MASTER DEVELOPMENT DRAINAGE PLAN & FINAL DRAINAGE REPORT

Engineering Review

MONUMENT ACADEMY

**JPS Project No. 040201
PCD File No. PPR-19-009**

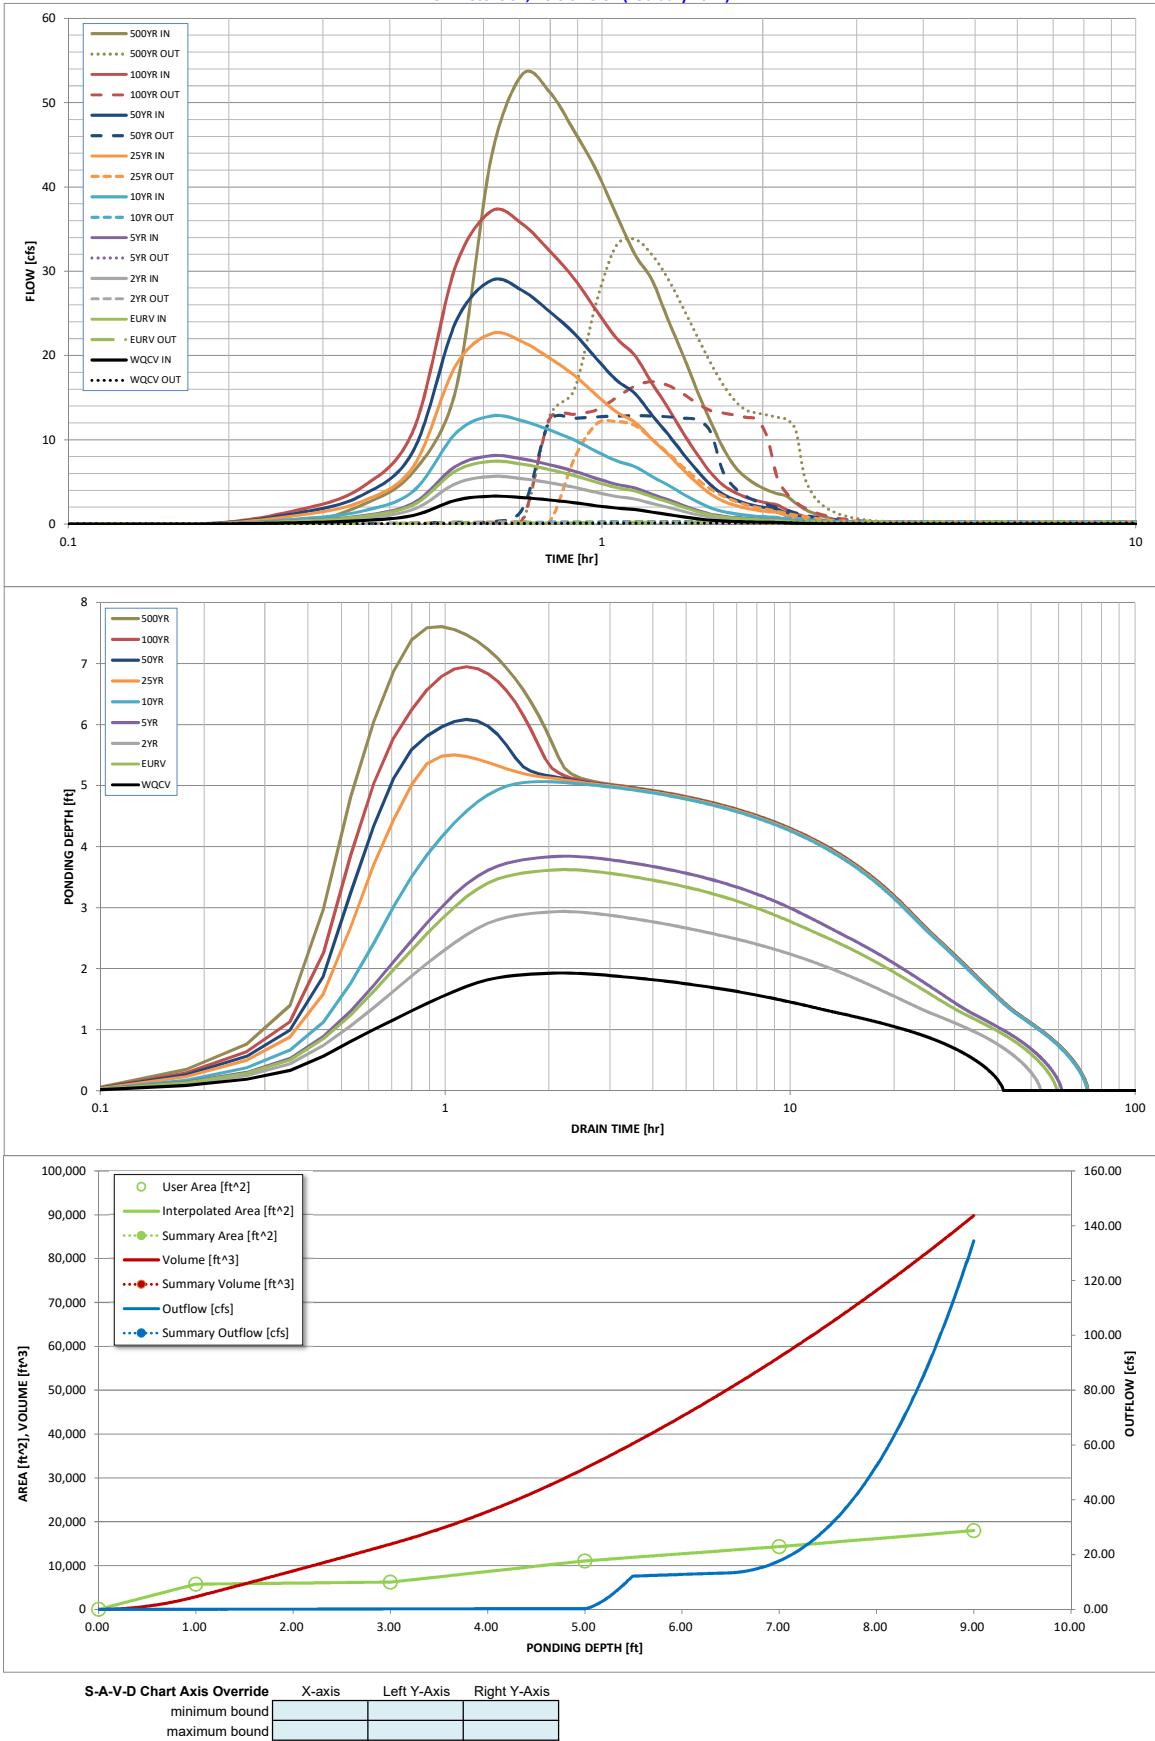
Provide values for this phase and ultimate development.

DETENTION POND M3
PLAN & DETAILS

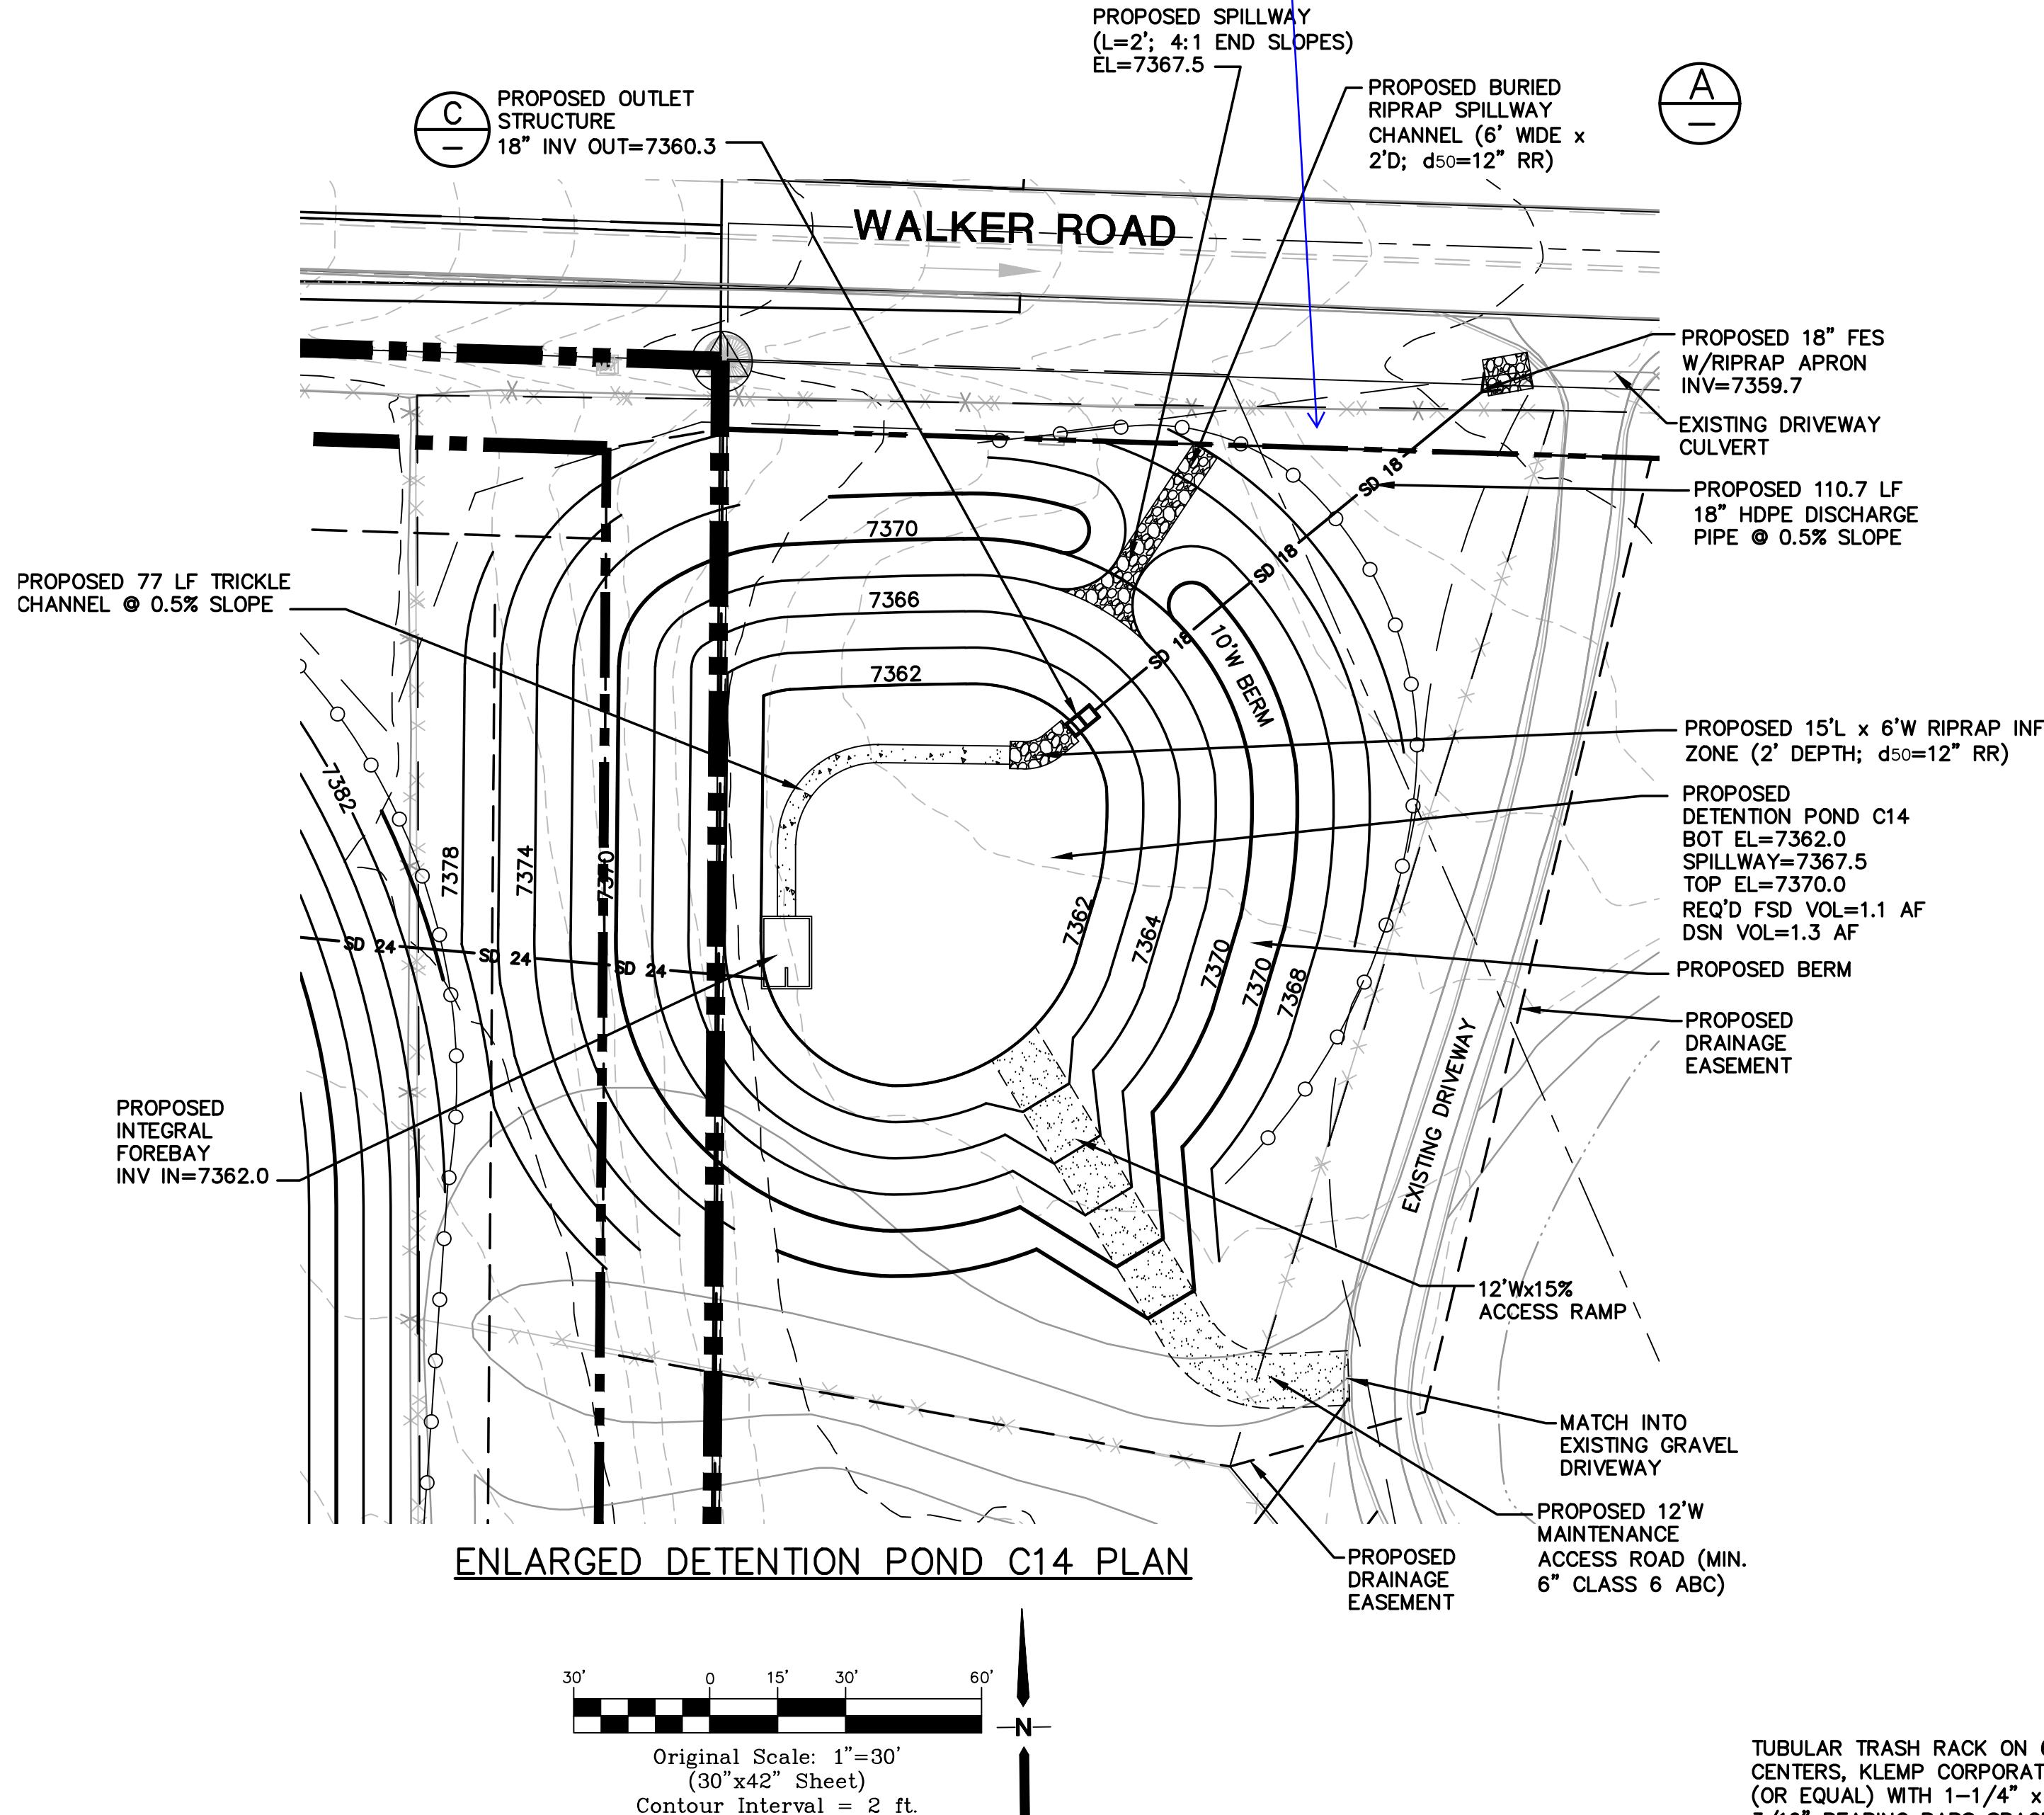
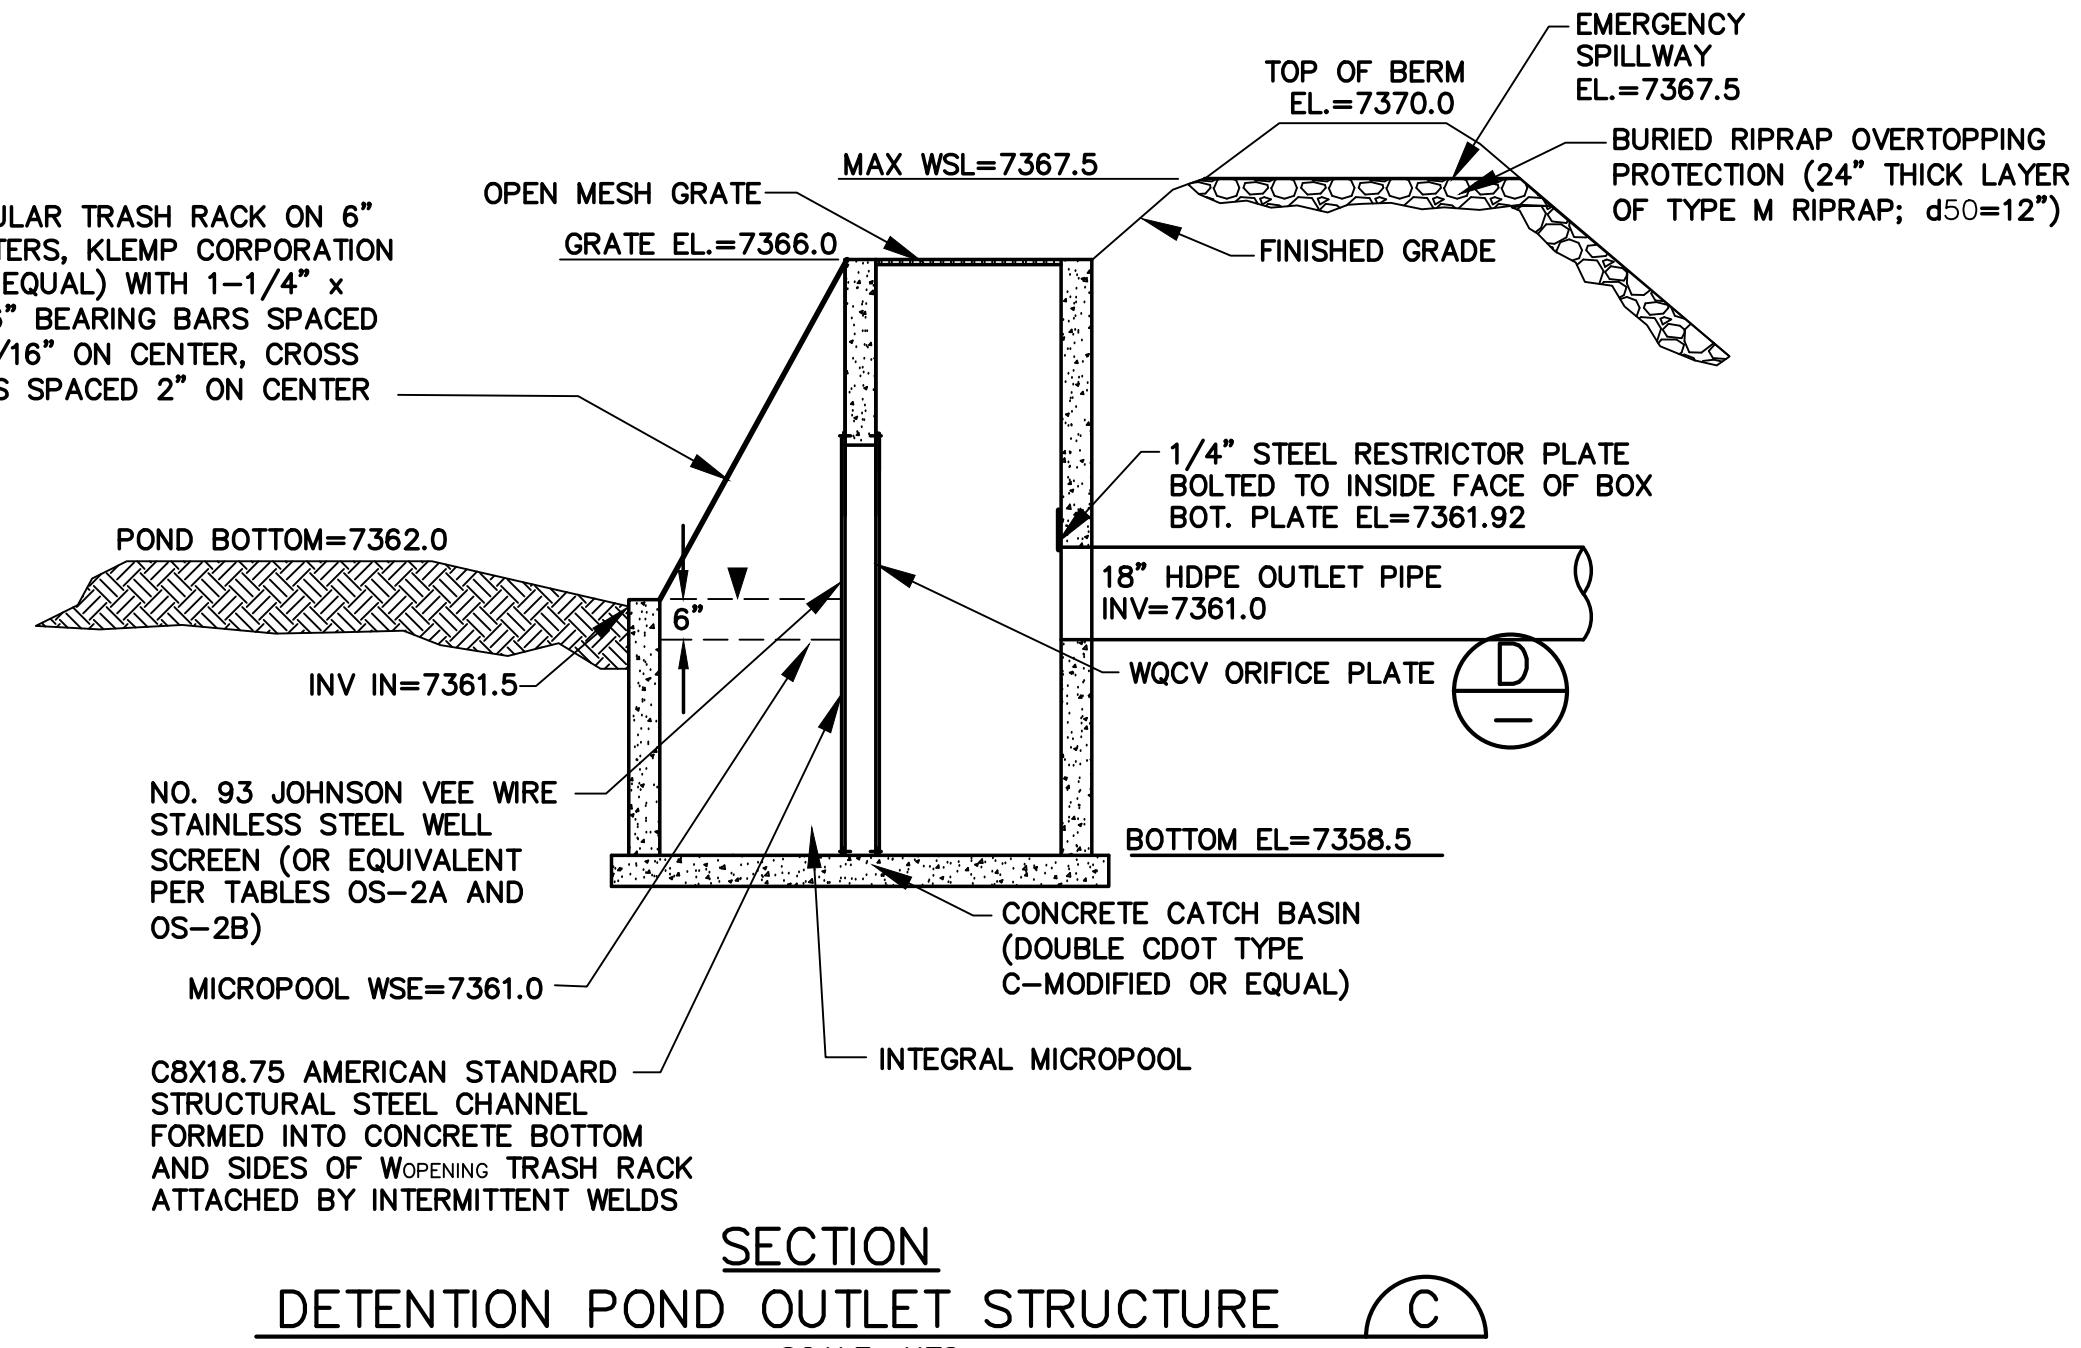
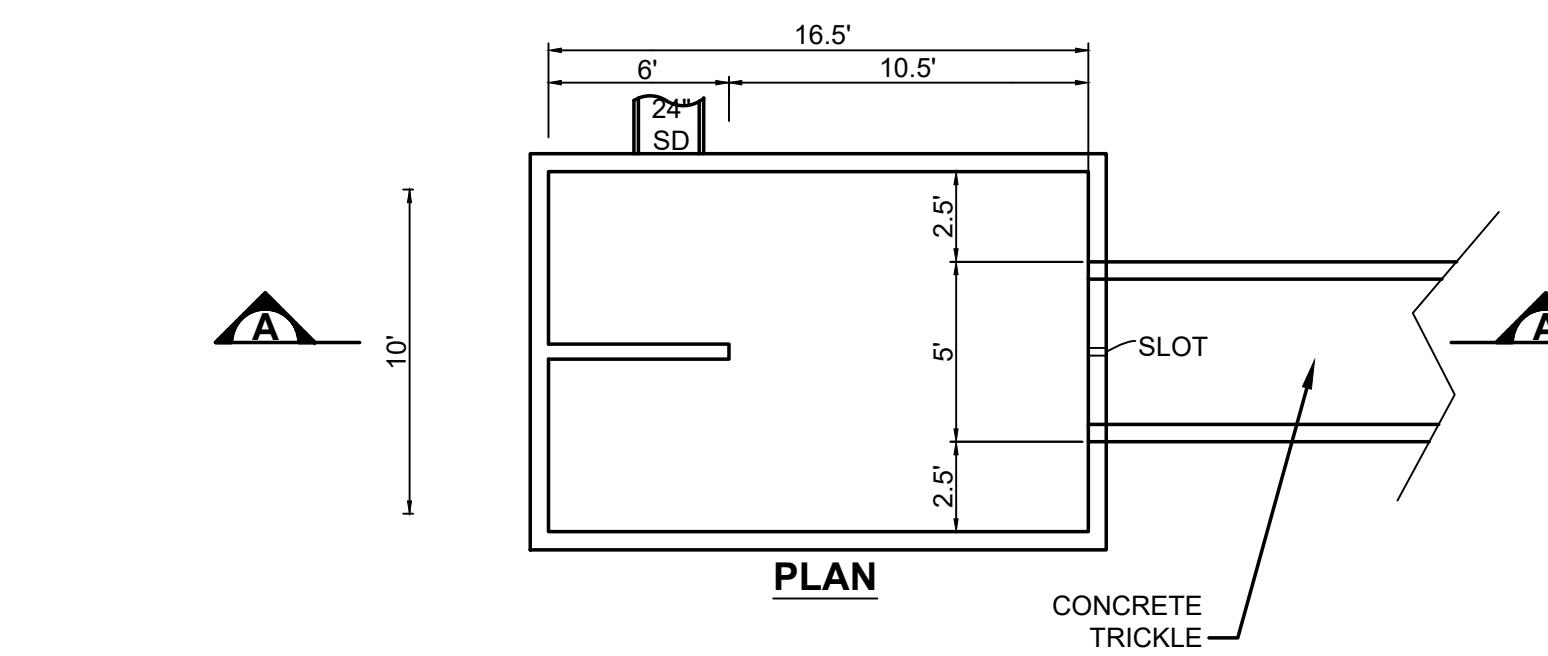
See GEC Plan
and CD comments.
